BLUE BIRD

**R09PB**

**SUBJECT: RECALL R09PB BATTERY POWER CABLE ROUTING**

# Battery Cable Routing **RECALL**

Lower cover panel

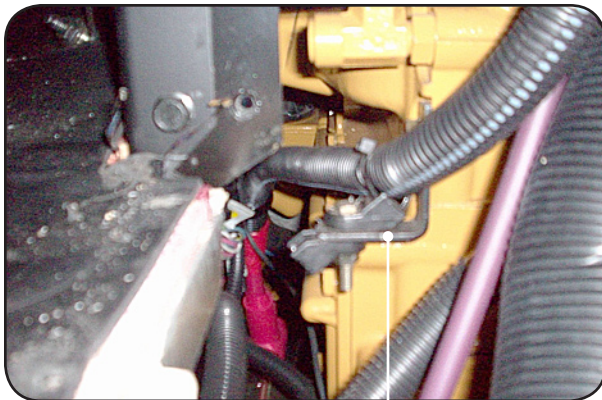
6.1 Remove the Power Distribution Unit (PDU) cover.

6.2 Remove the fasteners securing the lower cover panel to the PDU.

PDU pulled outward at right side to gain access to cables at rear of engine

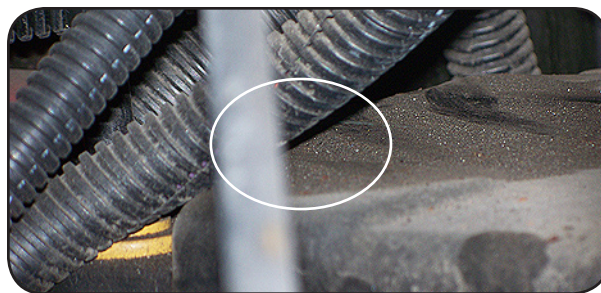
7.1 Remove the fasteners which mount the PDU. Carefully slide the right side of the PDU rearward far enough to view the wiring behind the engine.

7.2 Locate the two button-head cable ties which secure battery cables to the PDU. If either of the button-head cable ties are broken, missing, or damaged during the removal of the PDU, install new button-head cable ties (0024706) before reinstalling the PDU.

7.3 Inspect the battery cables for any evidence of contact with the rear of the engine, chaffing, or other damage. (Some harnesses may be attached to the engine lifting eye; those are not battery cables.)

Area of possible cable damage against front edge of transmission cover plate

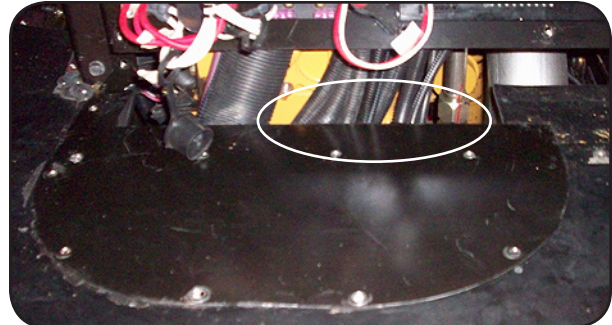
7.4 Inspect all the harnesses passing under the front edge of the transmission cover, as follows:

- If no contact between the transmission cover and harnesses is evident, proceed to step 8.
- If any evidence is found of chaffing or other damage due to contact against the transmission cover, perform **Sub Procedure B: Relocate Transmission Cover**.

## SUB PROCEDURE B: RELOCATE TRANSMISSION COVER

- 8.1 Remove the fasteners for the transmission cover plate.
- 8.2 Slide the transmission cover plate rearward approximately ½".
- 8.3 Install the lower cover panel between the Power Distribution Unit and the transmission plate with the existing fasteners.
- 8.4 Slide the transmission cover plate rearward until the rear of the transmission cover plate is 10" from the vertical surface of the lower panel.

- 8.5 Using a .218" drill bit with a drill stop set at 1 ¼", using the transmission plate as a guide, drill new attaching holes for the transmission cover plate. Reinstall the transmission cover plate in the new location, using the original fasteners.

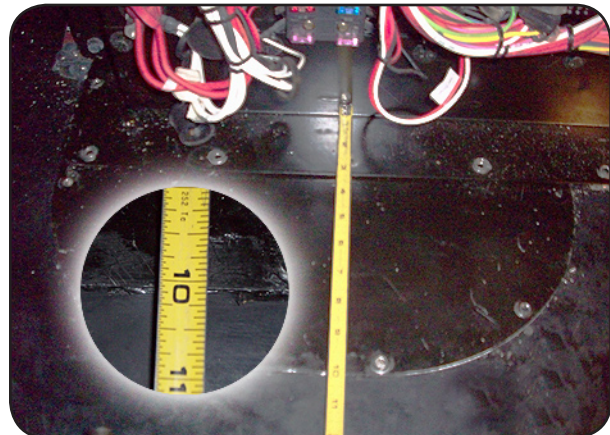
**1** If any evidence of cable loom contact with the engine, chafing, or other damage is evident, or if clearance between the battery cable(s) and any part of the engine is less than the required minimum ½" but cannot be repositioned, inspect further to determine the extent of damage:

- If the loom has been rubbed, but no damage to the battery cable inside has occurred, then install cable protector (BB # 0040818) between the engine and battery cable. Wrap the protector around the cable loom and secure it with two Cable Ties (BB # 0029999) as shown below.
